May 30, 2002
IPN-02-041

Subject: Indian Point Nuclear Generating Unit No. 3
Docket No. 50-286
**Request for License Amendment for 1.4% Measurement
Uncertainty Recapture Power Uprate**

**ANALYSIS OF PROPOSED
TECHNICAL SPECIFICATION CHANGE REGARDING
1.4% MEASUREMENT UNCERTAINTY RECAPTURE
POWER UPRATE**

1.4% Measurement Uncertainty Recapture
Power Uprate Application Report

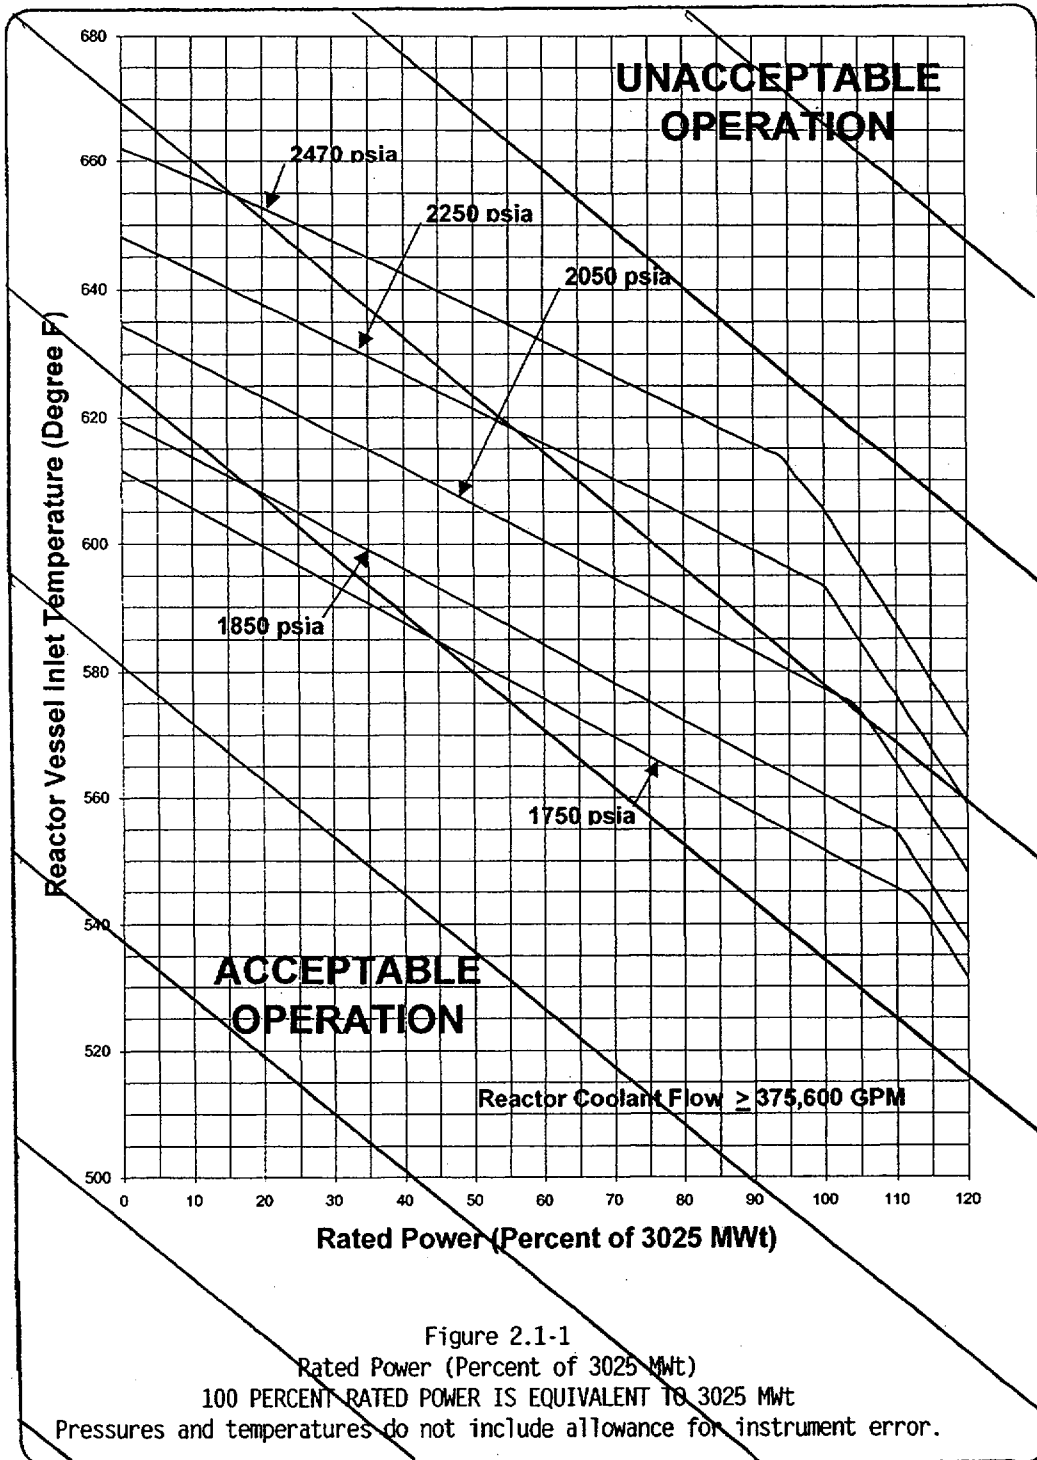
3067.4

Figure 2.1-1
 Rated Power (Percent of 3067.4 MWt)
 100 PERCENT RATED POWER IS EQUIVALENT TO 3067.4 MWt
 Pressures and temperatures do not include allowance for instrument error.

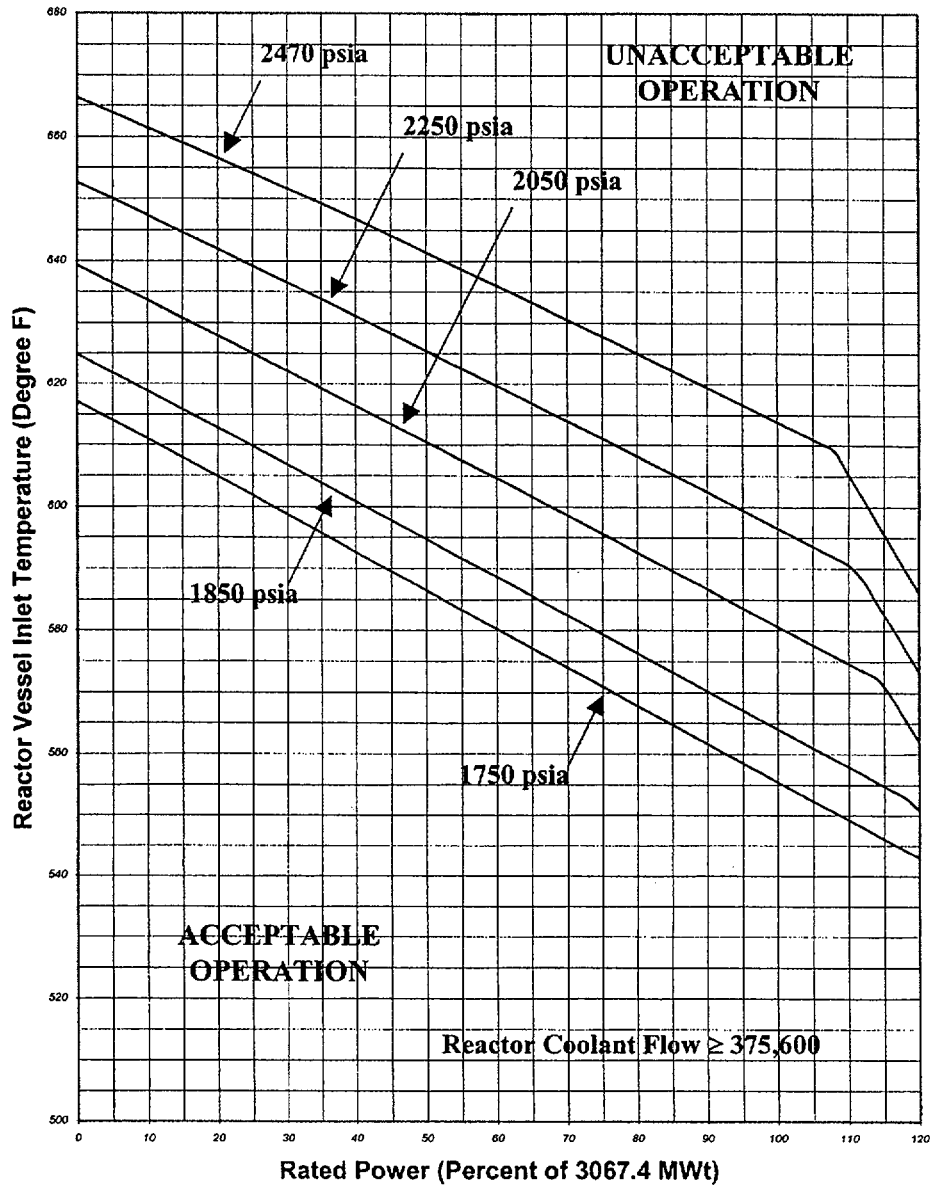
- b. Indian Point 3 Technical Specification SL Figure 2.1-1, which shows the loci of points of thermal power, reactor coolant system pressure and vessel inlet temperature for which the calculated DNBR is no less than the Safety Limit DNBR value or the average enthalpy at the vessel exit is less than the enthalpy of saturated liquid, is being revised to indicate: (1) the core thermal limits in this figure change based upon the effect that the 1.4% power uprate has on the exit boiling limit lines shifting, as well as on a more conservative analysis of axial offset control performed in anticipation of a future change from Constant Axial

INSERT A

Figure 3.4.3-1:
Heatup Limitations for the Reactor Coolant System

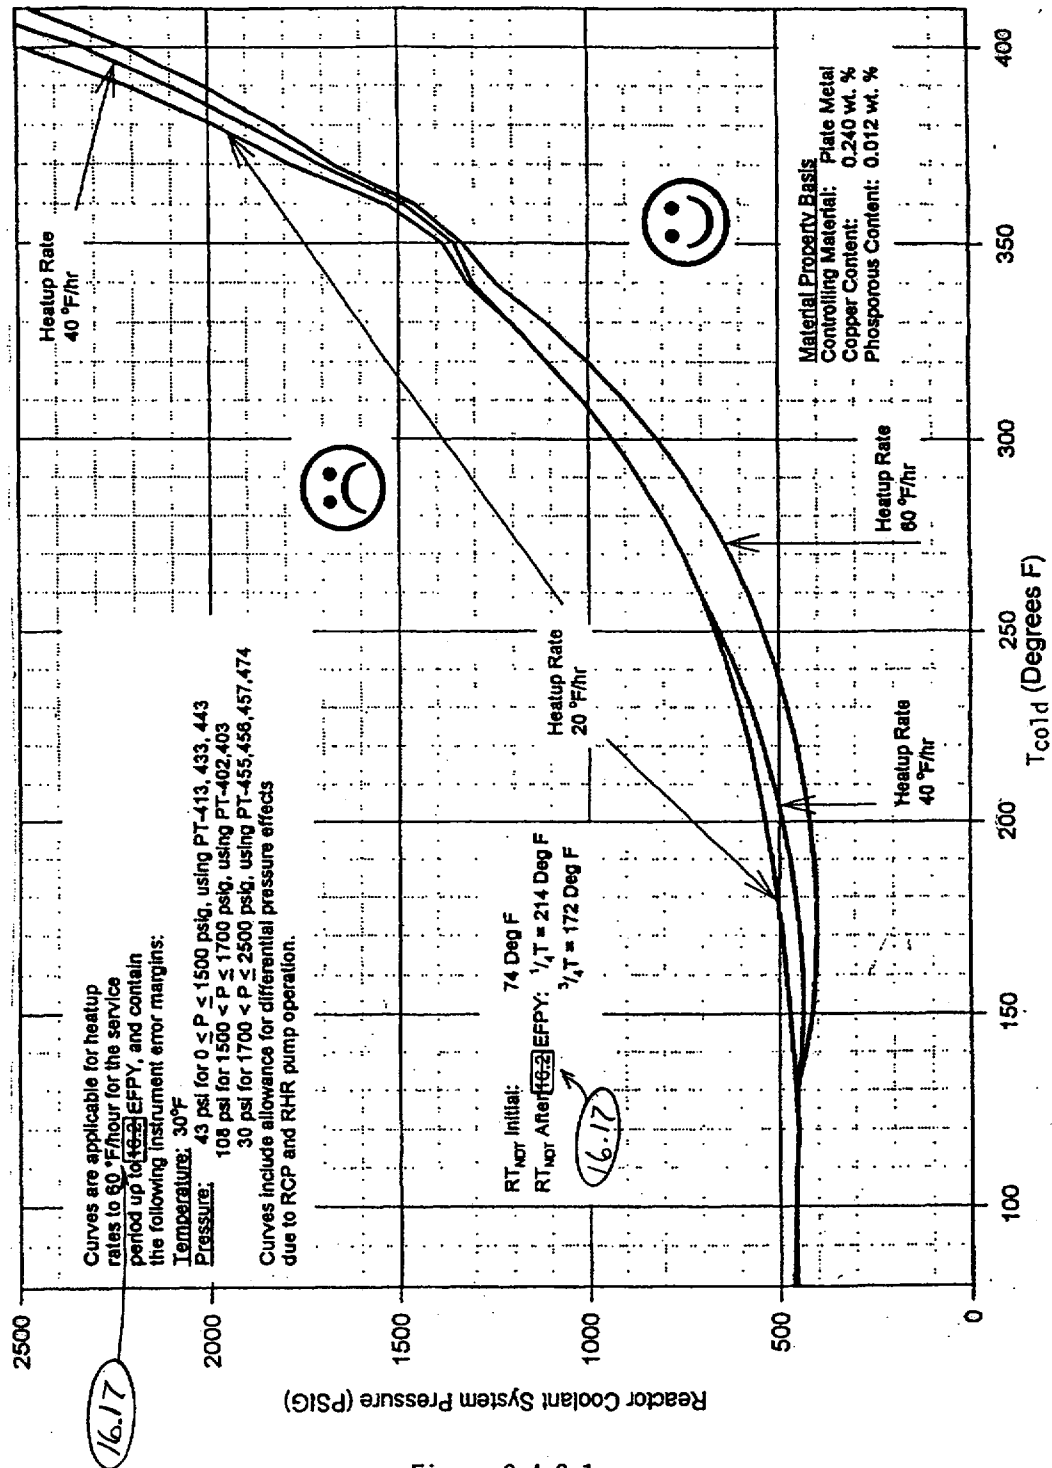
- d. Indian Point 3 Technical Specification LCO 3.4.3 Figure 3.4.3-1(Heat up Curve), Figure 3.4.3-2 (Cool down Curve), Figure 3.4.3-3 (Hydrostatic and In-service leak test curve, Figure 3.4.12-1 (Maximum allowable nominal PORV set point for LTOP (Ops) curve), Figure 3.4.12.2 (Pzr Limits for OPS Inoperable curve for one charging pump feed to RCS), Figure 3.4.12-3 (Pzr Limits for OPS Inoperable curve for three charging pumps and/or one HHSI pump feed to RCS), and Figure 3.4.12-4 (Secondary side limits for RCP start curve with secondary side hotter than primary side) all changed the value for Effective Full Power Years (EFPY) to reflect a slight effect due to the mini-uprate on the applicable service period for all of these curves.
